**Recommended Amendments to the  
2009 International Residential Code**  
North Central Texas Council of Governments region

The following sections, paragraphs, and sentences of the *2009 International Residential Code* are hereby amended as follows: Standard type is text from the IRC. Underlined type is text inserted. ~~Lined through type~~ is deleted text from IRC. A double asterisk at the beginning of a section identifies an amendment carried over from the 2006 edition of the code and a triple asterisk identifies a new or revised amendment with the 2009 code.

FIGURE R602.6.1  
TOP PLATE FRAMING TO ACCOMMODATE PIPING

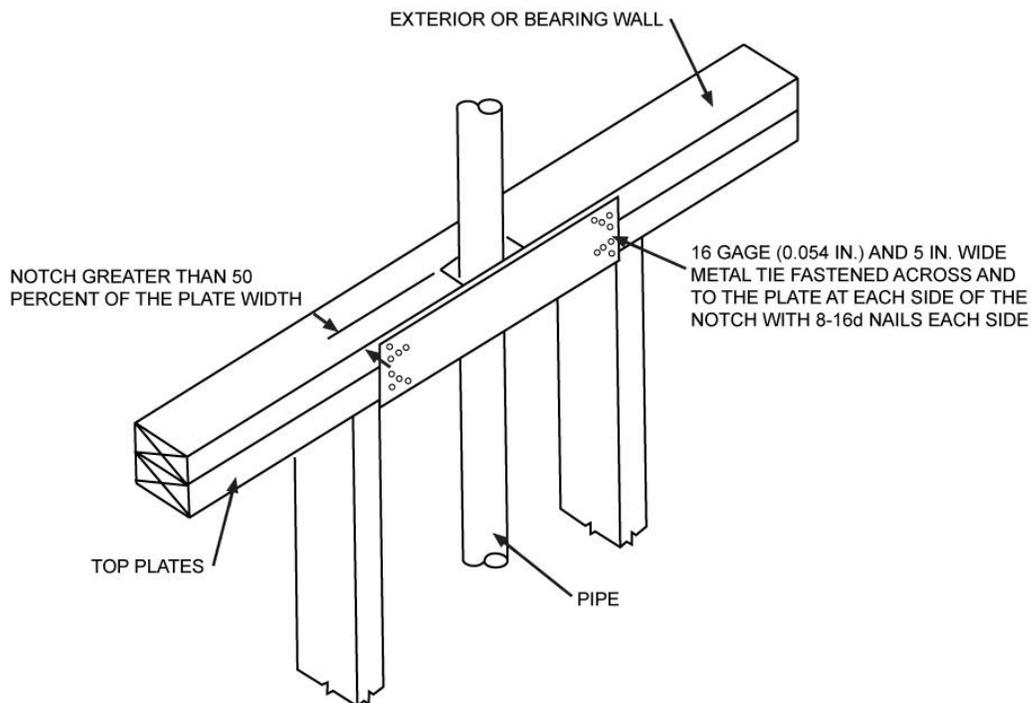
**R602.6.1 Drilling and notching of top plate.** When piping or ductwork is placed in or partly in an exterior wall or interior load-bearing wall, necessitating cutting, drilling or notching of the top plate by more than 50 percent of its width, a galvanized metal tie not less than 0.054 inch thick (1.37 mm) (16 Ga) and 4 ½ inches (38 mm) 5 inches (127 mm) wide shall be fastened across and to the plate at each side of the opening with not less than eight 10d (0.148 inch diameter) having a minimum length of 1 ½ inches (38 mm) at each side or equivalent. Fasteners will be offset to prevent splitting of the top plate material. The metal tie must extend a minimum of 6 inches past the opening. See figure R602.6.1.

\*\*\*Figure R602.6.1; delete the figure and insert the following figure:

*(Reason: reflects regional practice and to comply with P2603.2.1. Also provides additional assurance of maintaining the integrity of the framing by spreading the nailing pattern.)*
